Campaign No. 2021020037, March 2021

SUBJECT: **Model GLA-Class vehicles (247 platform)**
Model Year 2021
Check installation position of shield at front passenger airbag

Figure 1

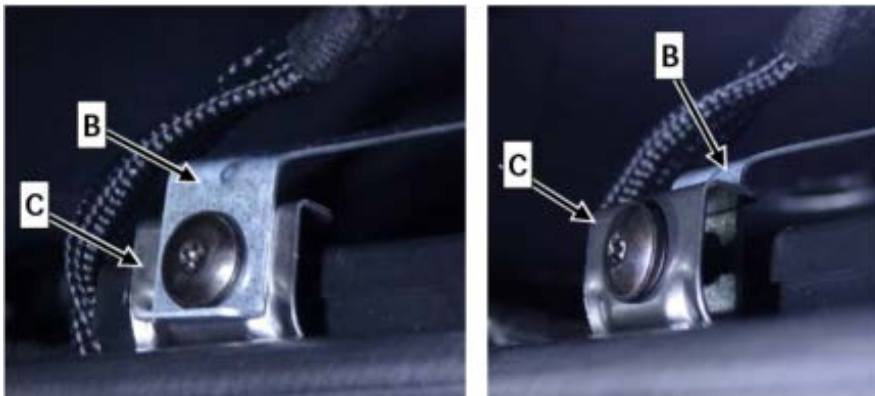
1. Remove cover (**A, figure 1**) at side at instrument panel.
2. Check installation position of shield (**B, figure 2**) at front passenger airbag.
 - i** Perform visual check through opening in instrument panel using a suitable flashlight.
